ADDENDUM NO. 1

Job No. F70C616E
SAND ISLAND STATE RECREATION AREA
SEWER SYSTEM IMPROVEMENTS
PHASE 2: PUMP STATION 3 RELOCATION & FM 3 REPLACEMENT
Honolulu, Oahu, Hawaii

02/22/21

PHASE 3 – SL D AND SFM CS6
SCALE: 1" = 100'

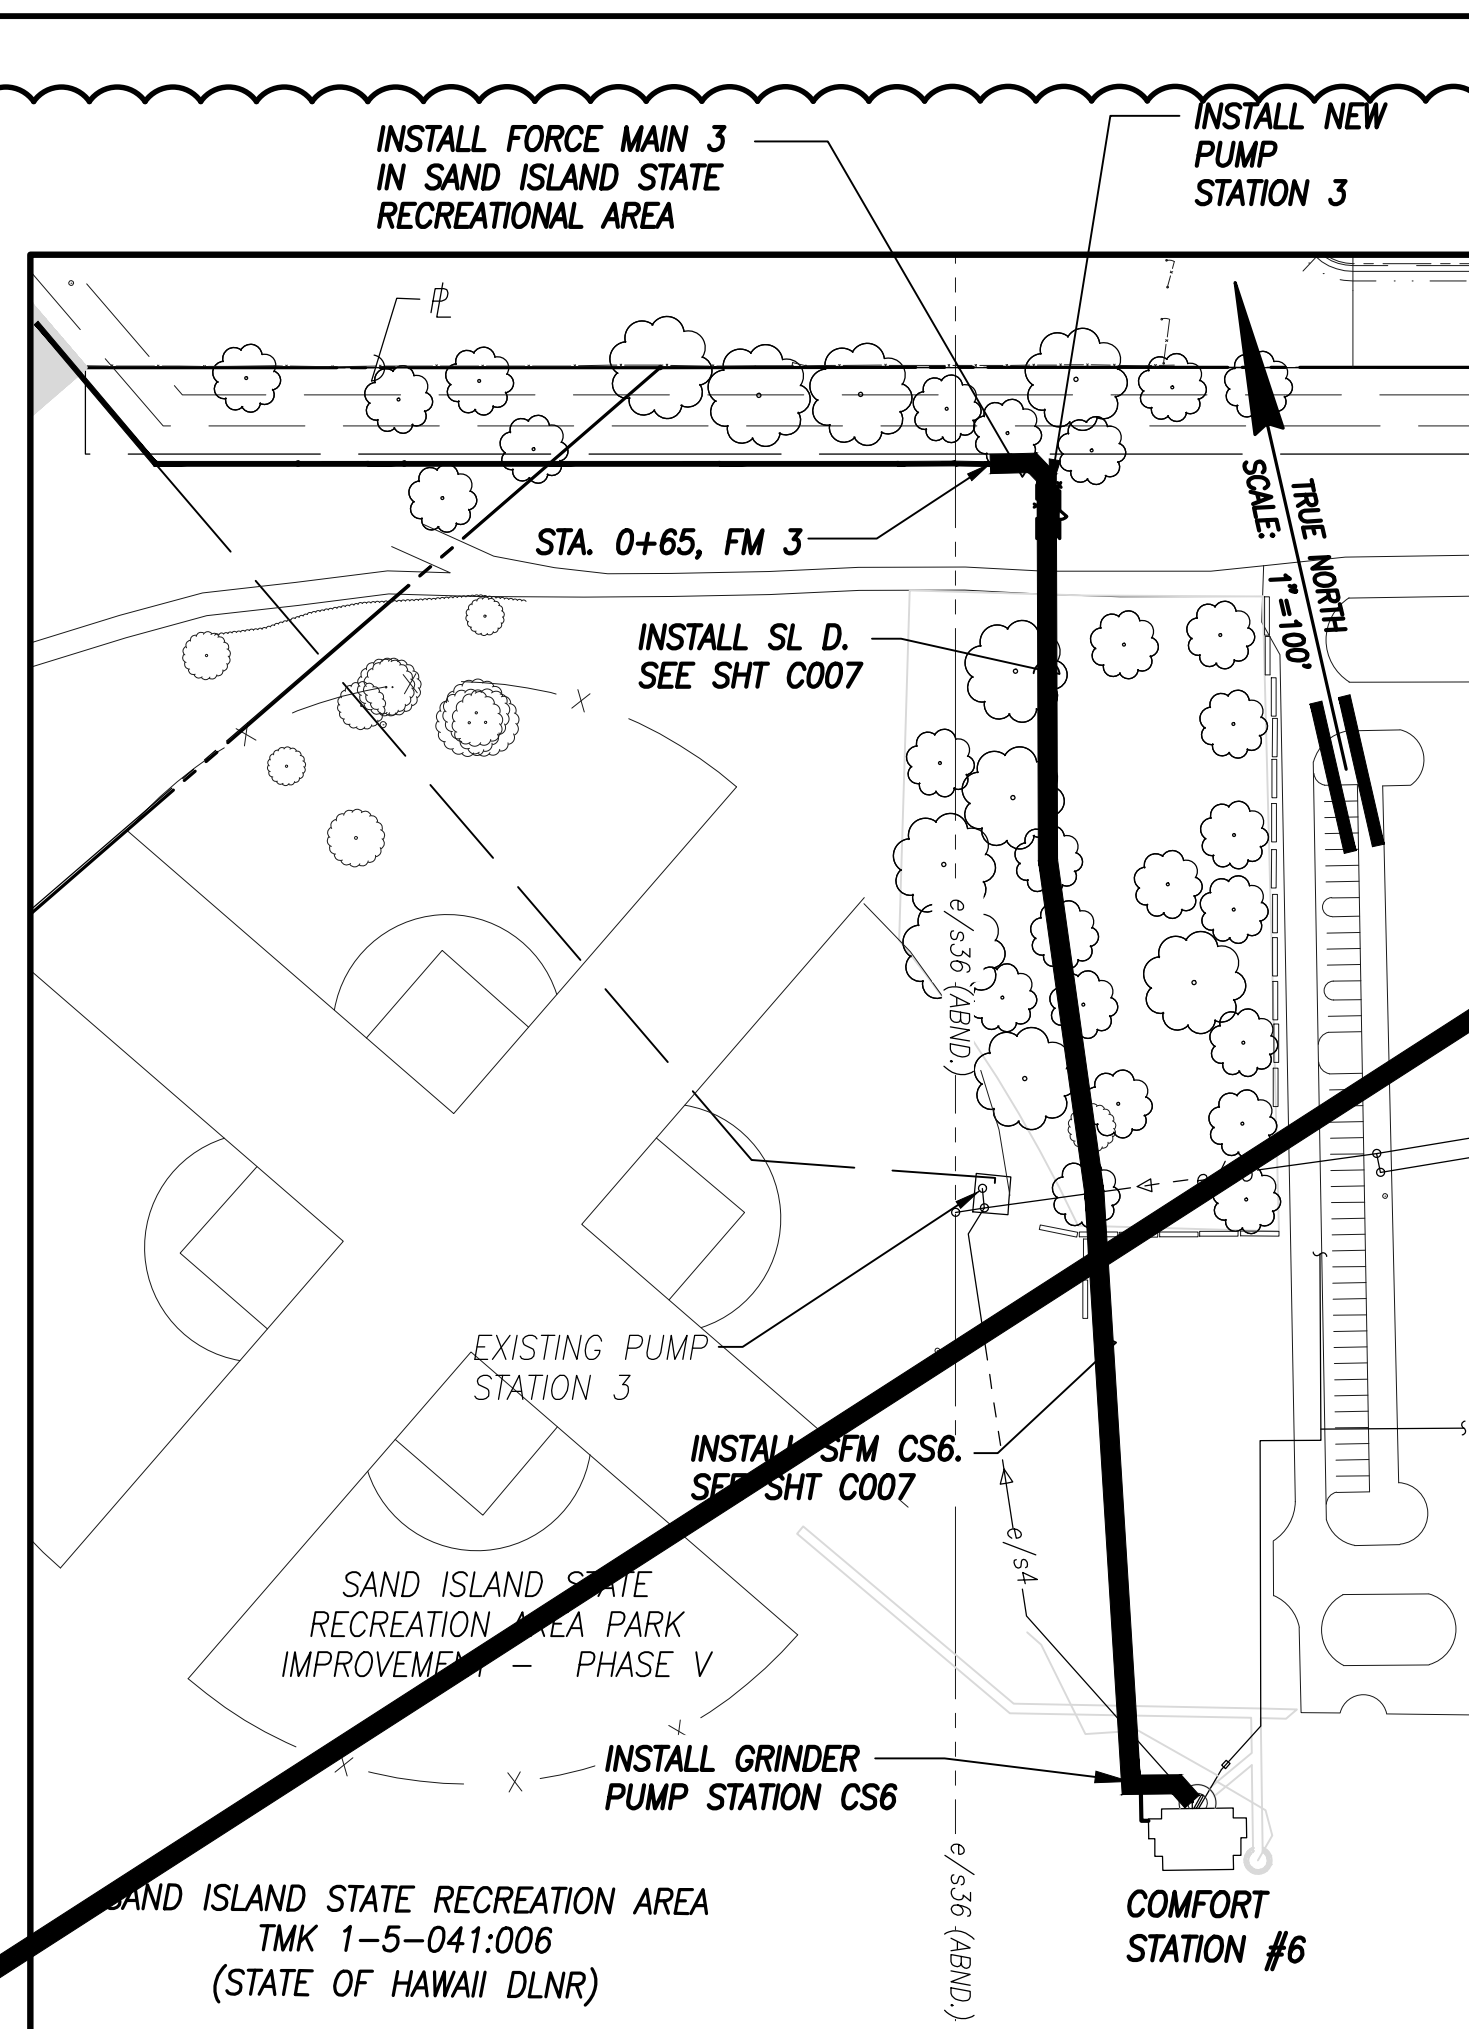
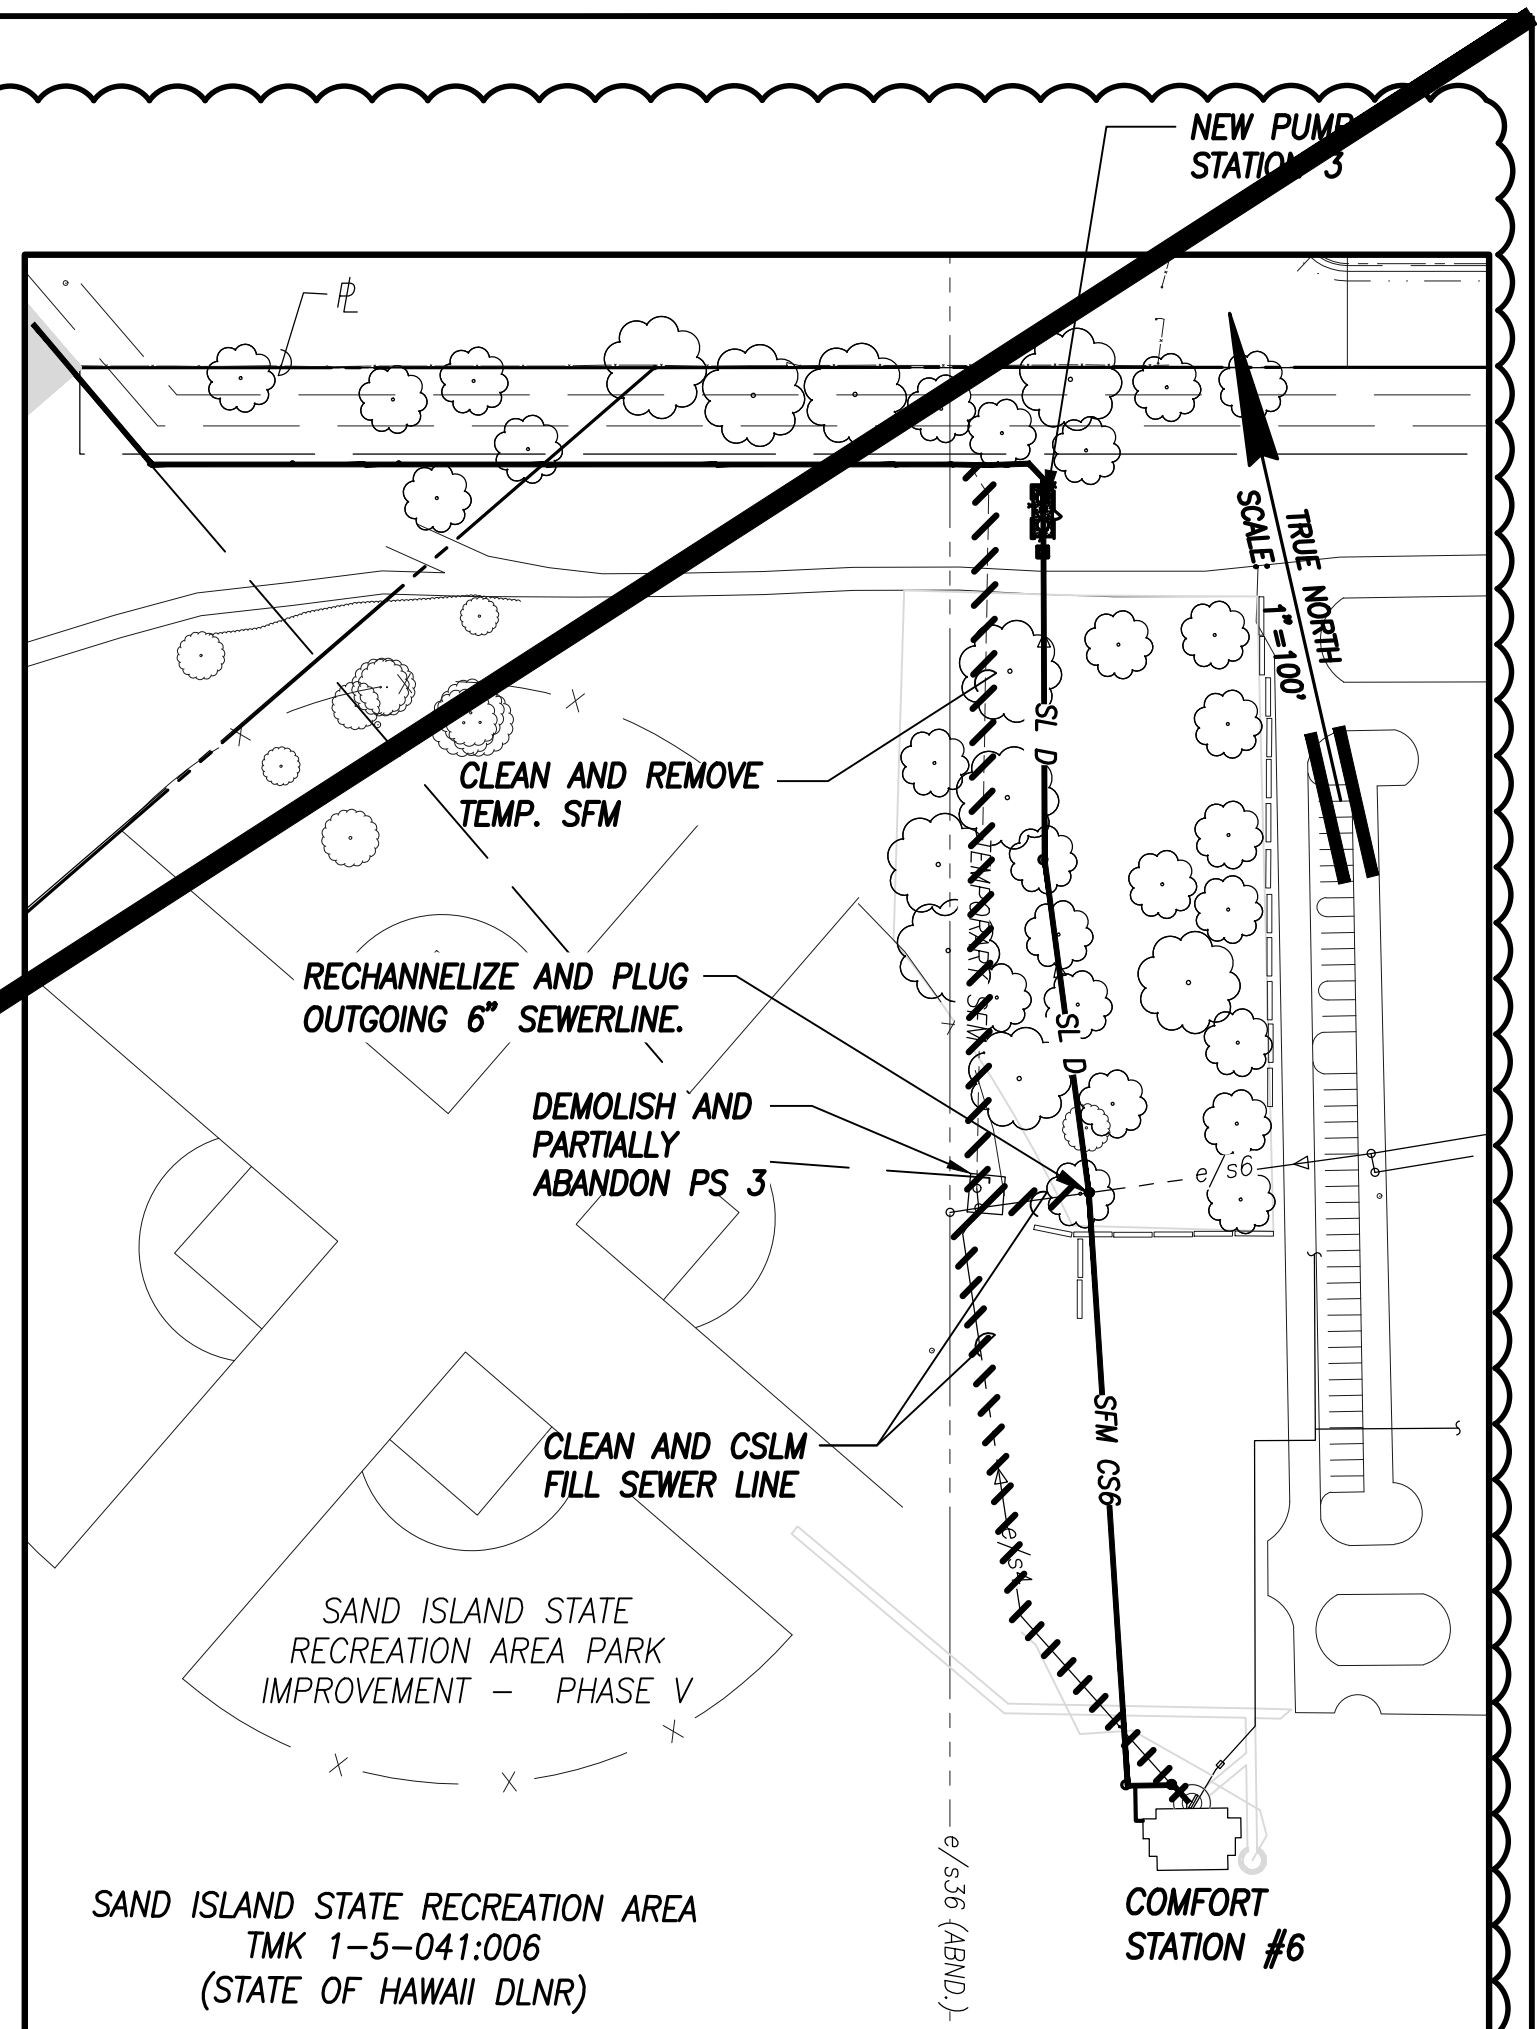
2. Sheet C004, "Erosion Control Plan"
 - a. Revised limits of disturbed area.
 - b. Revised compost filter socks alignment.
